DESIGN REVIEW COMMITTEE

January 21, 2026 6:00 PM

AGENDA

Jasmine Blake-Stewart Office Building
 3166 Dogwood Drive, Hapeville, GA 30354 - Fulton County
 BUILDING ELEVATIONS

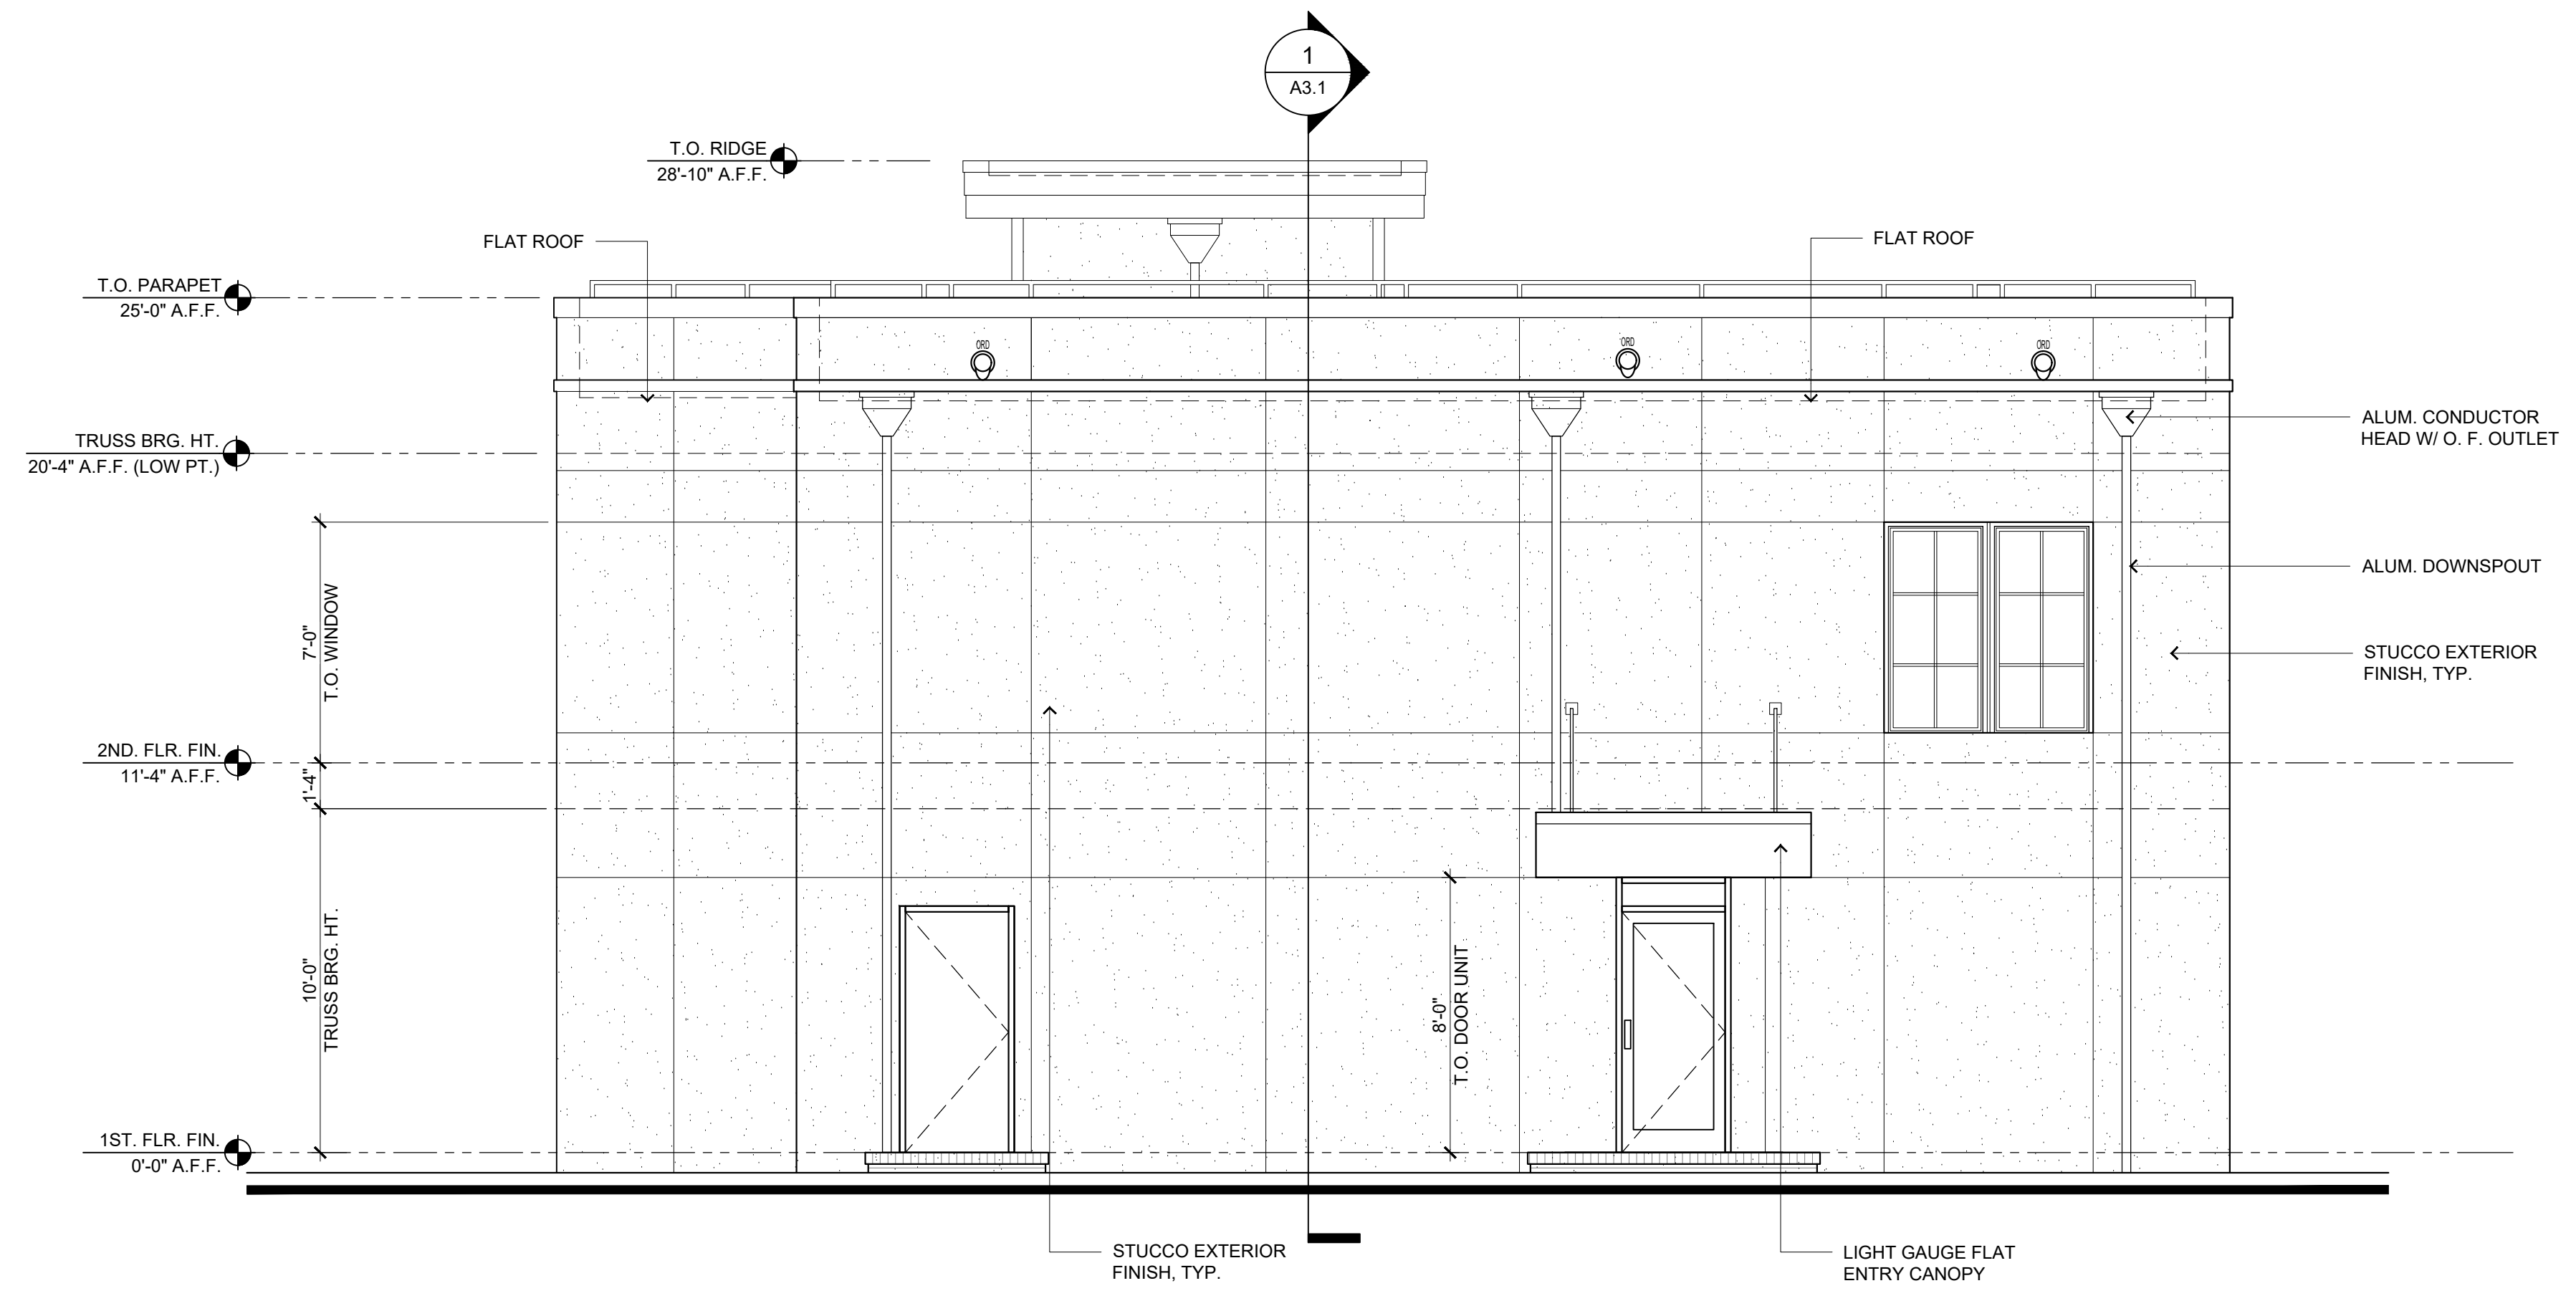
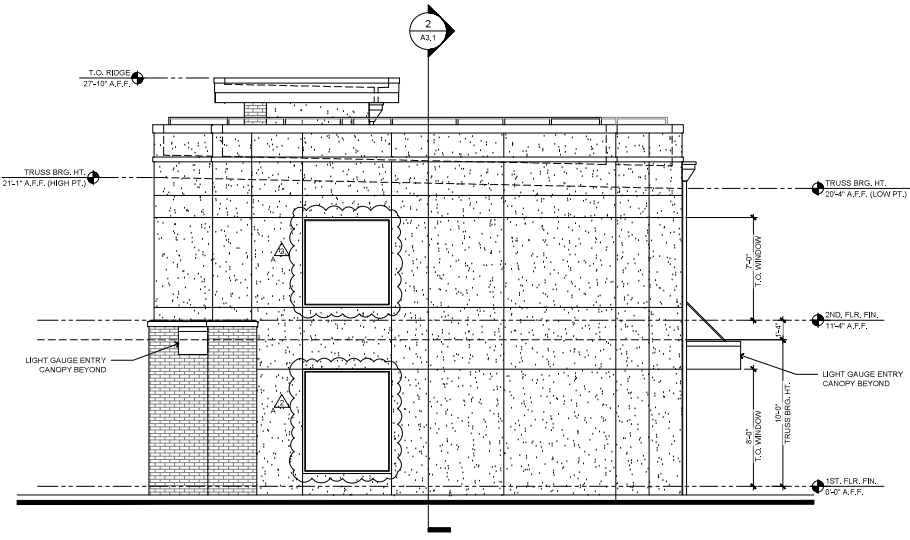
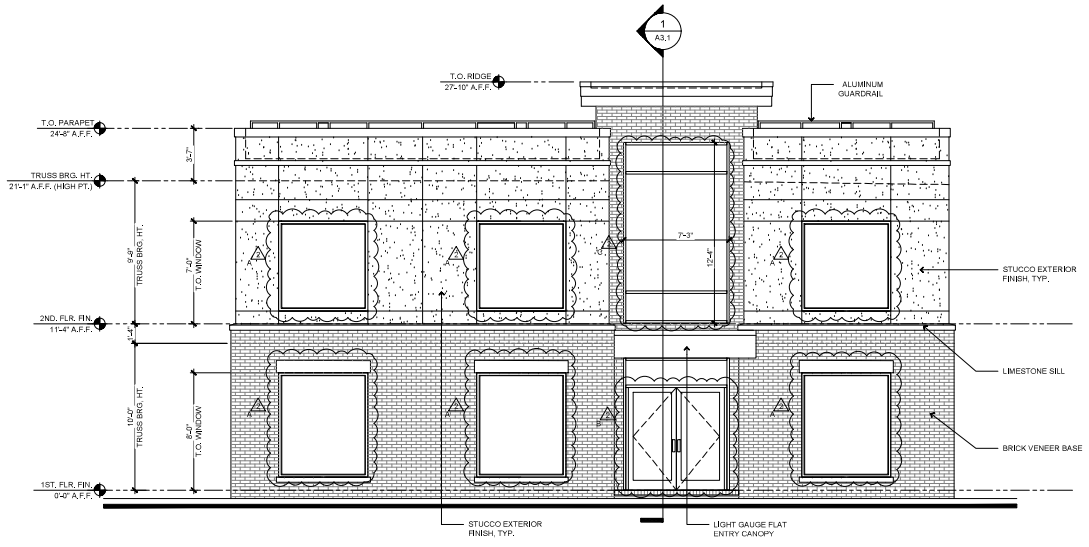
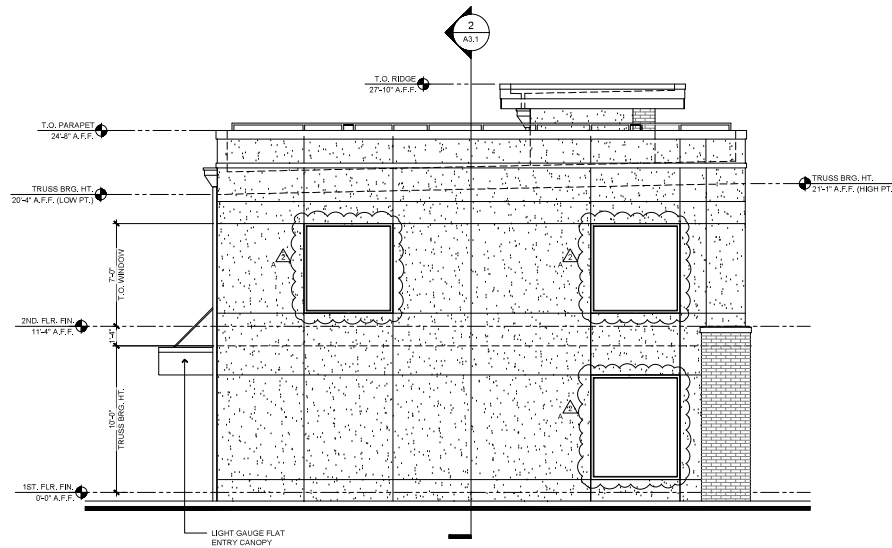
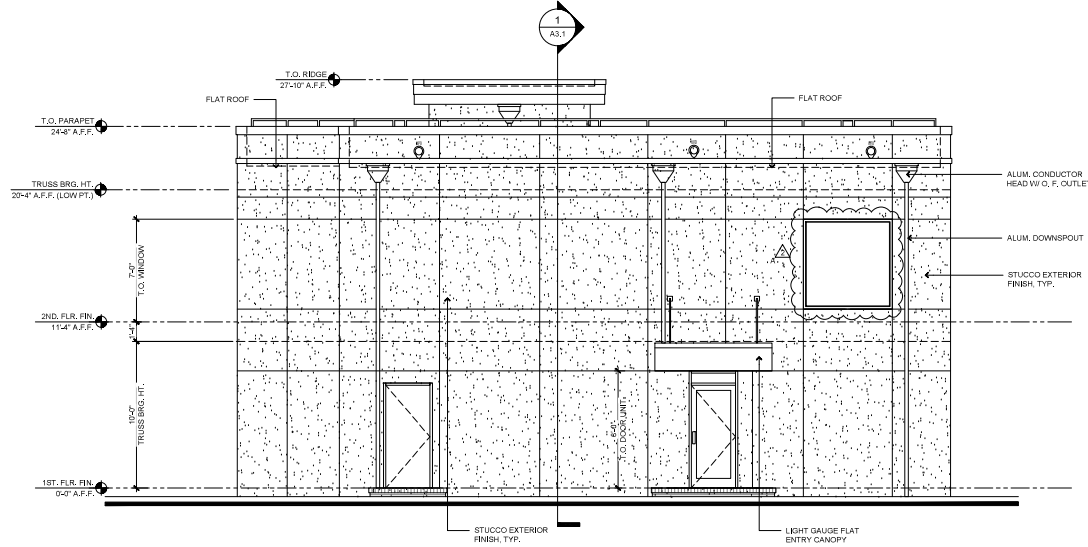
The requested change is to modify the windows from double-hung divided light windows to large pane windows on the lower and upper floors.

Proposed Change:

Front Elevation:

1. The revised elevation shows a double door with no side-lites and a double-glazed transom with no dividers above the main door.
2. The three 1st floor windows are single windows with no center mullion and no divided lites.
3. The three 2nd floor windows are single windows with no center mullion and no divided lites.
4. The large window above the front entry is separated horizontally with three panels of glass.

Right Side Elevation:

1. The single 1st floor window is a single window with no center mullion and no divided lites.
2. The single 2nd floor window is a single window with no center mullion and no divided lites.

Left Side Elevation:

1. The single 1st floor window is a single window with no center mullion and no divided lites.
2. The two 2nd floor windows are single windows with no center mullion and no divided lites.

Rear Elevation:

1. The single 2nd floor window is a single windows with no center mullion and no divided lites.

No dimensions for the new windows were provided. The glass transoms on the lower floors are not present. The heights of the windows are not provided to determine if the 10' to 12' dimension has been met. It is not clear if the front door is still 70% glass. The upperstory windows do not have the vertical shape as required above. The lower story windows are also not as vertically pronounced as the approved windows. The applicant should provide additional information per above. The Design Review Committee may assess whether the revised windows meet the intent of the storefront treatment as prescribed in the Standards.
